Access Compliance Report

Public Rights-of-Way

(Curb Ramps)

Intersection ID: 11783	Main Street: N_GRAHAM_ST	Cross Street: W_5TH_ST	Location: S
ADA ID: 68380169B63D	Ramp Type: Perp	Initial Pass/Fail: Fail	Overall Compliance: No
		Severity Score: 12.5

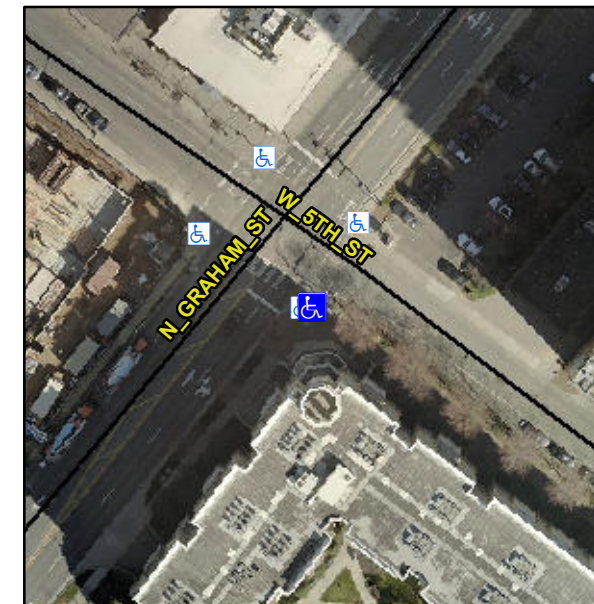
Compliance	Description	Data	Compliance	Description	Data
N/A	Ramp Length (in)	84.0	No	Ramp Slope (%)	11.0
Yes	Ramp Width (in)	48.0	Yes	Ramp XSlope (%)	0.2
N/A	Flare Type LT	N/A	N/A	Flare Type RT	N/A
N/A	Flare Slope LT (%)	N/A	N/A	Flare Slope RT (%)	N/A
N/A	Flare Traversable LT?	N/A	N/A	Flare Traversable RT?	N/A
N/A	Landing Length (in)	N/A	N/A	DWS Provided?	N/A
N/A	Landing Width (in)	N/A	N/A	DWS Contrast?	N/A
N/A	Landing Slope (%)	N/A	N/A	DWS Length (in)	N/A
N/A	Landing X Slope (%)	N/A	N/A	DWS Full Width?	N/A
N/A	Landing Curb? (Y/N)	N/A	N/A	DWS Offset (in)	N/A
N/A	Shared Landing?	N/A			
N/A	Gutter Ponding?	N/A	N/A	Gutter Slope (%)	N/A
N/A	Gutter Lip Ht (in)	N/A	N/A	Gutter X Slope (%)	N/A
N/A	Painted X Walk1?	Yes	N/A	Painted X Walk2?	N/A
	X Walk 1 Direction	To NE		X Walk 2 Direction	N/A
N/A	X Walk 1 Width (in)	110.0	N/A	X Walk 2 Width (in)	N/A
	X Walk 1 Slope (%)	0.7		X Walk 2 Slope (%)	N/A
	X Walk 1 X Slope (%)	0.8		X Walk 2 X Slope (%)	N/A

Remove & Replace Entire Ramp.

R304.2.2
